City of Oakley
ADDENDUM NO. 1 to contract documents for
CIP 255 – Cypress Grove Pump Station Project

BID OPENING DATE: October 6, 2022 2:00 PM

Notice is hereby given that the following clarifications and revisions are made to the above referenced contract documents:

Updates to the Plans and Specifications:

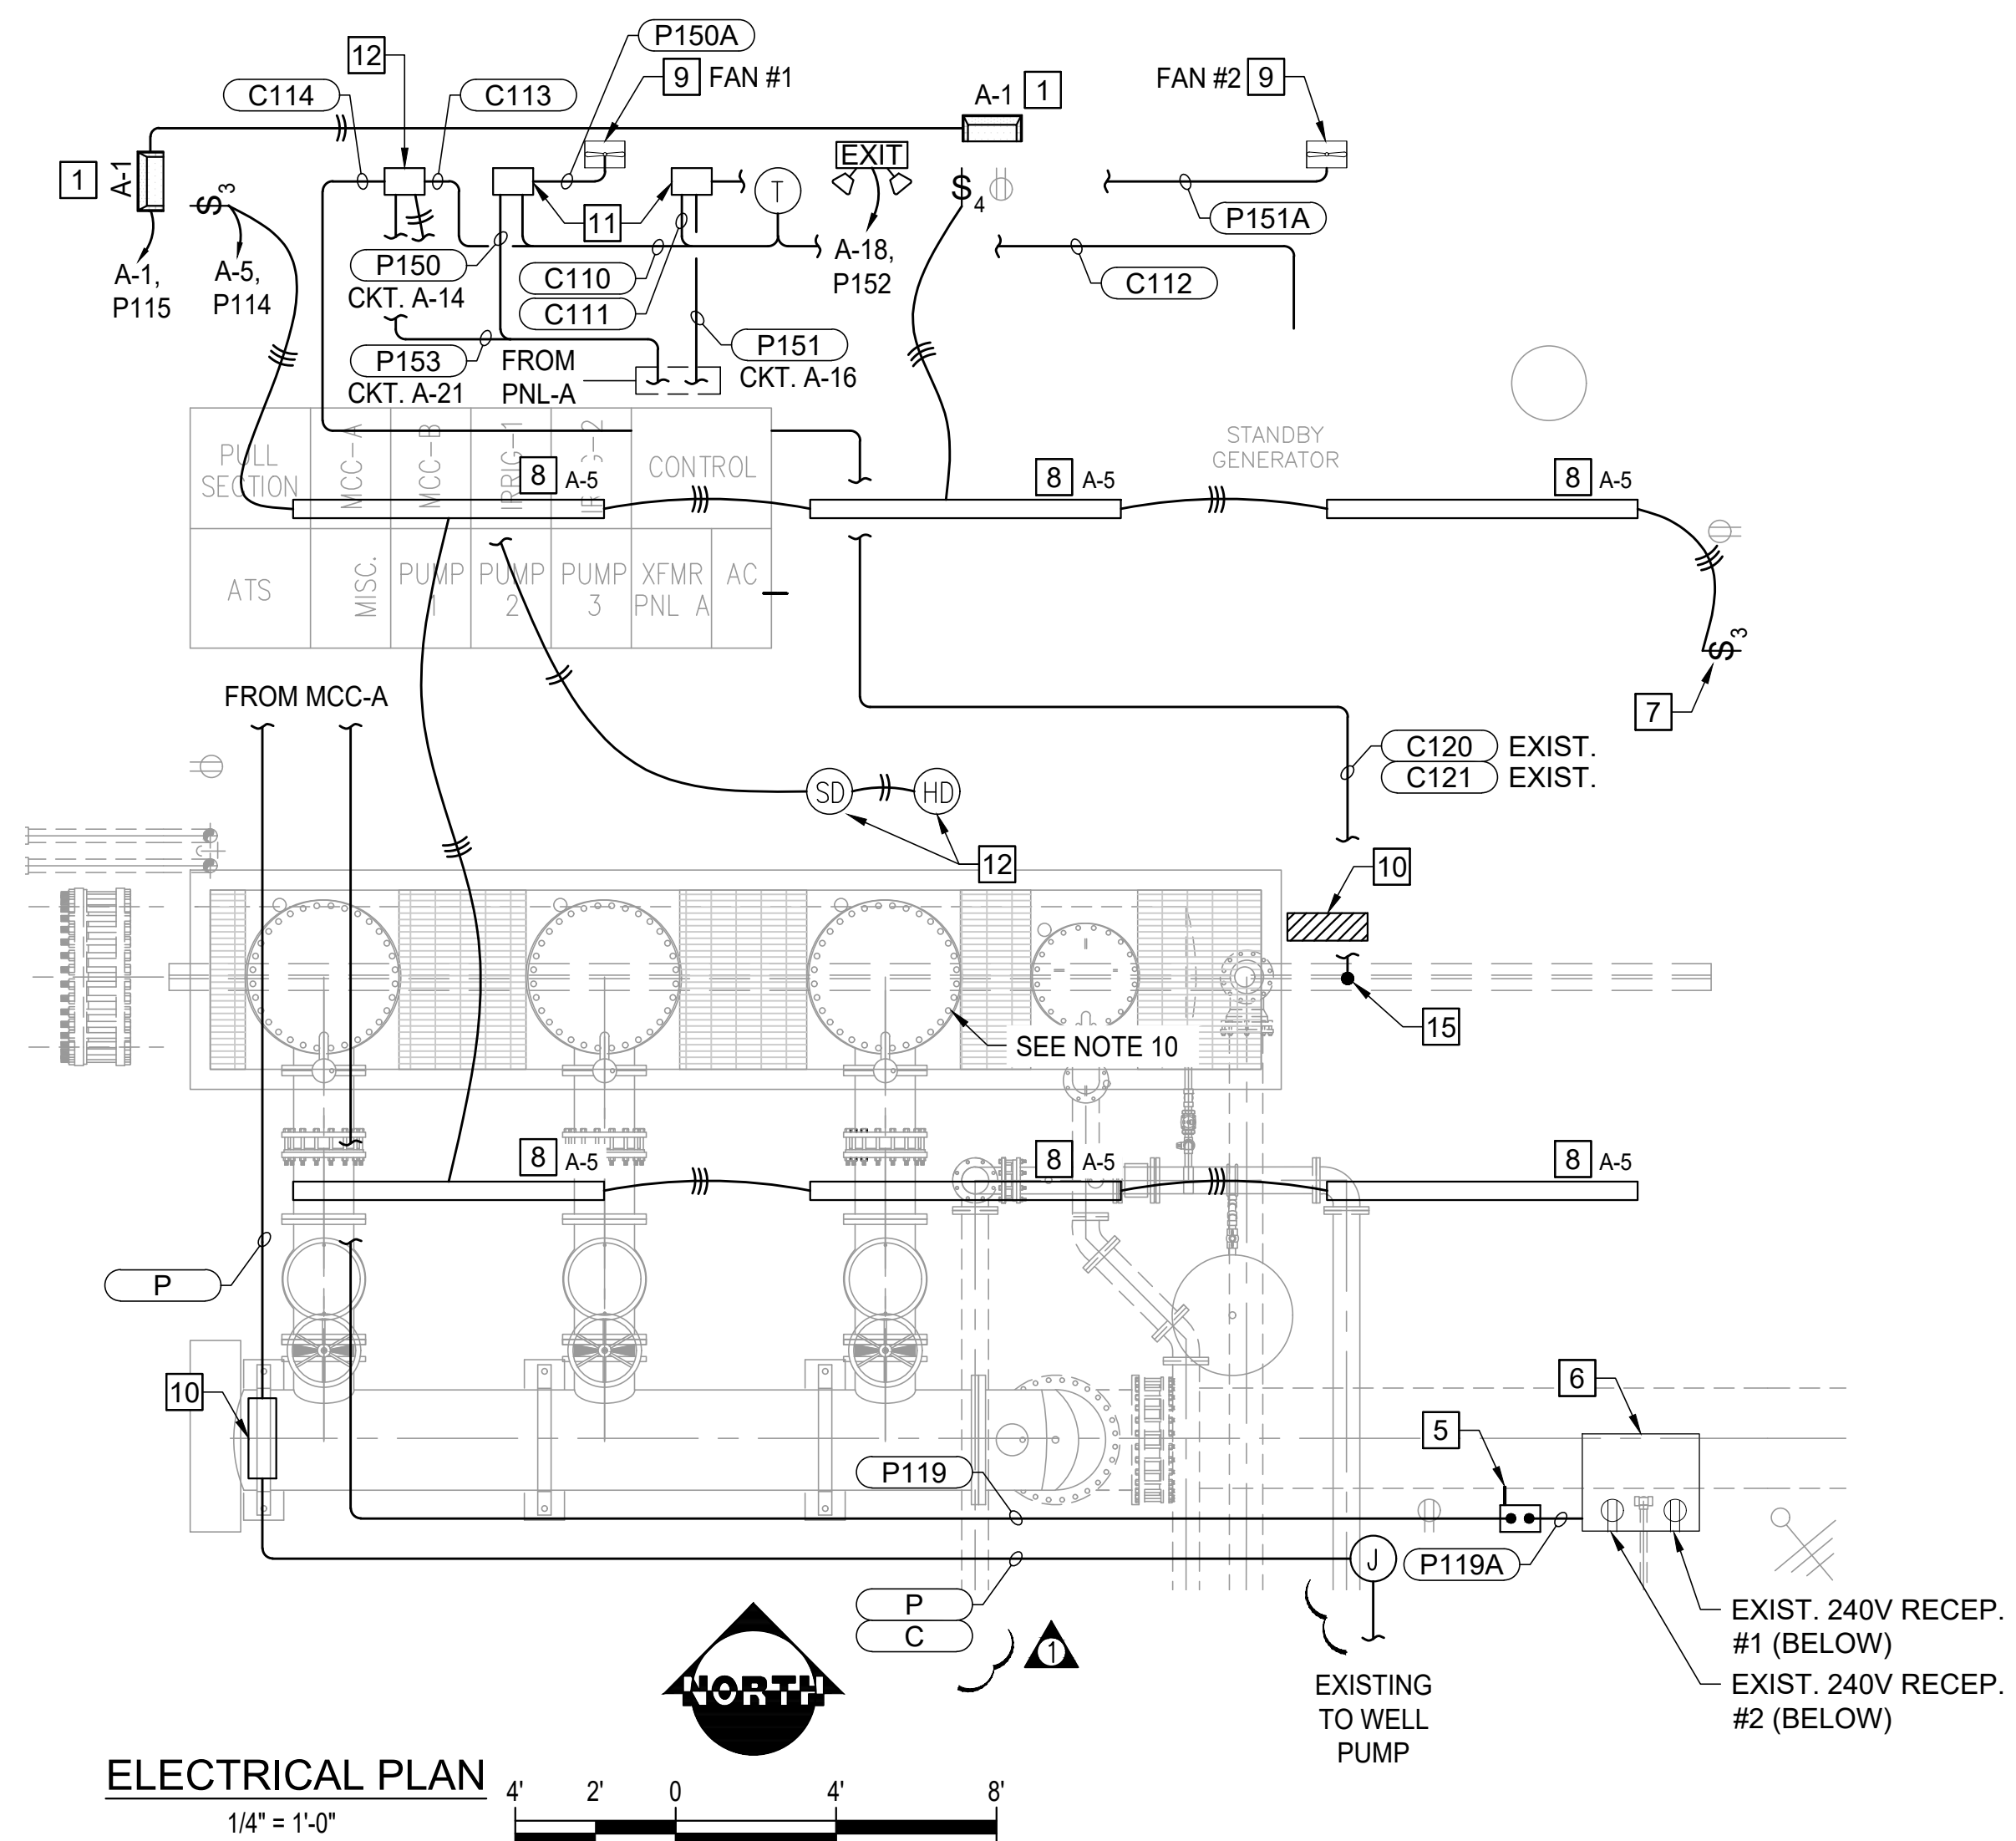
- 1 OUTDOOR WALL-PACK LIGHTS SHALL BE CONTROLLED BY PHOTOCCELL.
- 2 CKT. A-1 ON PANEL 'A' & CONDUIT TAG 'P-115' WILL NOW BE USED FOR OUTDOOR WALL PACK LIGHTING, RE-LABEL AS SUCH ON SCHEDULES.

- 3 CKT. A-5 ON PANEL 'A' & CONDUIT TAG 'P-114' WILL BE USED FOR REPLACEMENT CANOPY LIGHTS.
- 4 RE-LABEL PANEL 'A' SCHEDULE TO READ "240V RECEPTACLE #1" FOR CKTS. A-13 & A-15, & "240V RECEPTACLE #2" FOR CKTS. A-10 & A-12.

- 9 FAN, 120/230V AC, 1PH, 0.5 HP, WINDOW-MTD.
- 10 HMI PANEL, GUARDRAIL-MTD. (PANEL AND SYSTEM INTEGRATION SHALL BE A DEFERRED SUBMITTAL). RELOCATE - SEE DETAIL G SHEET E3.0. RE ROUTE EXIST WIRING
